REMARKS

Application No. 10/009,133
Amendment dated January 20, 2004
Reply to Office action of October 17, 2003

Annotated Sheet Showing Changes

FIG. 3

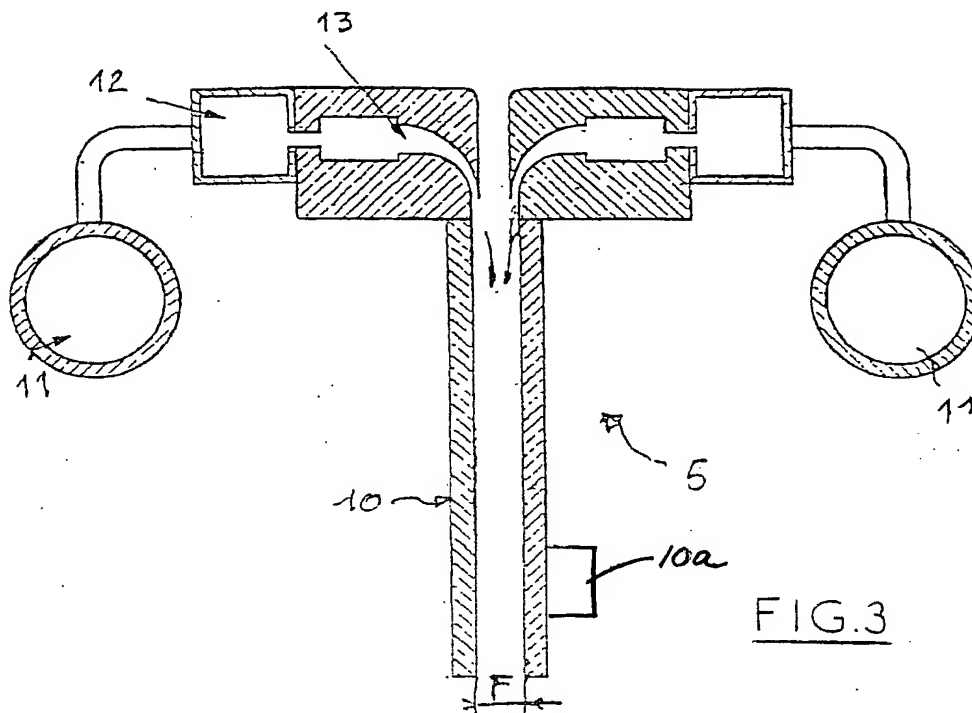
In reply to paragraph 3, it is not believed that it is appropriate to mark Fig. 3 as "Prior Art". Fig. 3 actually illustrates the adjustable width of the drawing slot 10. To that end, Fig. 3 is to be amended to include adjustment device 10a as shown in red in the informal copy of Fig. 3. There is also submitted a formal copy of Fig. 3 including this change. Support for the showing of the adjustment device 10a is found in the original specification at page 6, lines 23 - 25 (substitute specification page 6, lines 14-17), page 7, lines 26 - 29 (substitute specification page 7, lines 9-14), page 9, lines 26 - 34 (substitute specification page 8, lines 39-47), page 12, lines 4 - 6 (substitute specification page 10, lines 40-42), original claim 4, and claim 12.
